June 13, 2022

Re: Bowdoinham Planning Board Public Hearing Information requests:
Scott Gallant- 17 School Street, Bowdoinham, Maine (U01-017)

Statement of Deficiencies and Plan of Corrections

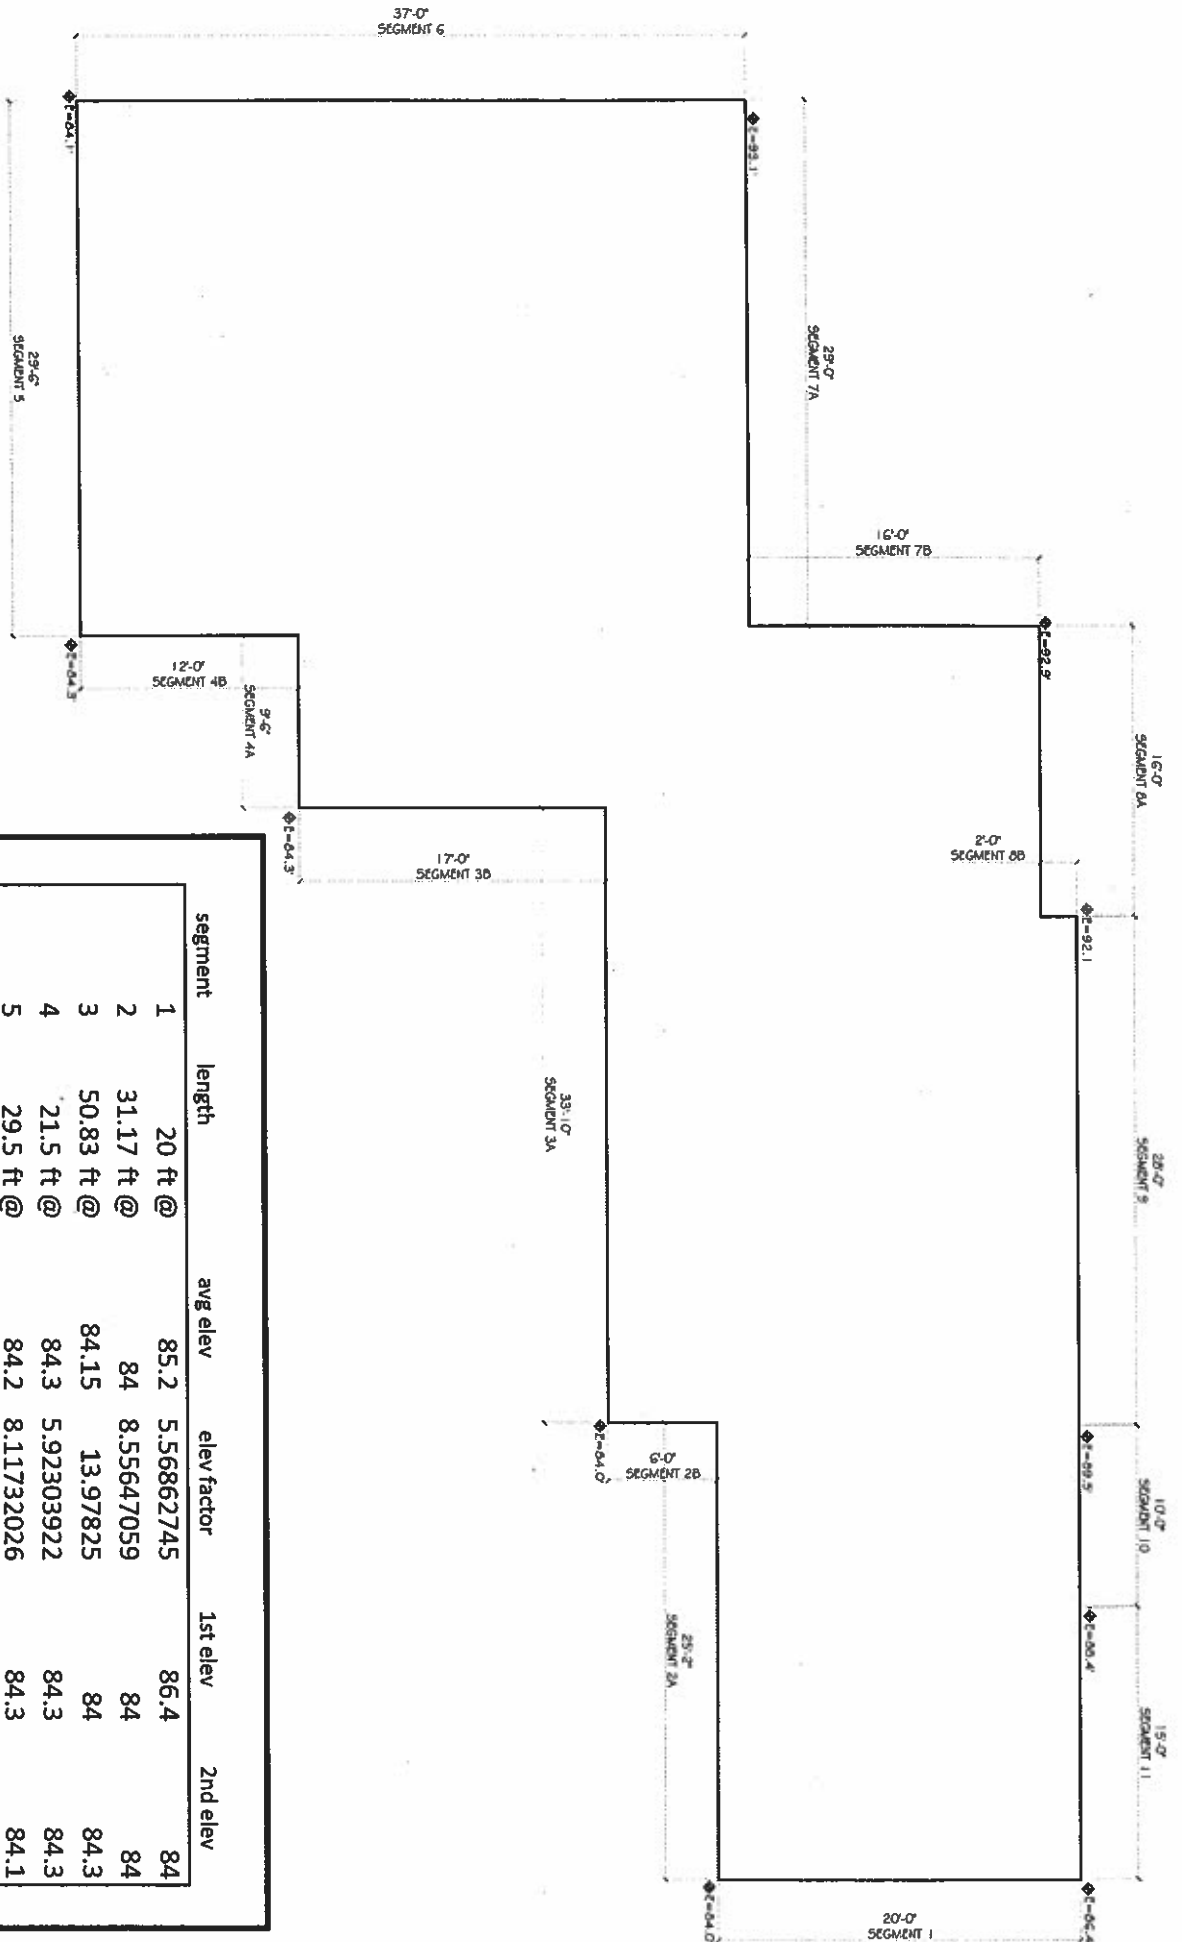
6. ISSUE	Issues found as described Please provide location of the manual pull station for the kitchen hood system. Also indicate the connection to the fire alarm system as required per NFPA 96	A manual pull station for the kitchen hood extinguisher system has been noted on the revised drawings, in addition to a note for connection to the fire alarm system per NFPA 96.

7. ISSUE	Issues found as described What will floor 2 be used for?	Floor 2 uses include marijuana grow space, receiving/storage, and retail store.
8. ISSUE	Issues found as described This project appears to be a grow facility with commercial kitchen and storage. Originally as presented I was under the impression there would be mercantile space. Please provide more information and a clearer picture of how this facility will be utilized. Also, provide clarification if there will be any extraction processes occurring as the process from growing, storage to cooking appears to leave out part of the processing which would be crucial to the review process. If there is no mercantile occupancy within this building this project, by state statute, may not need a full	The uses include a commercial kitchen (no extraction), marijuana grow facility, a Residential unit, and Marijuana Sales Store.
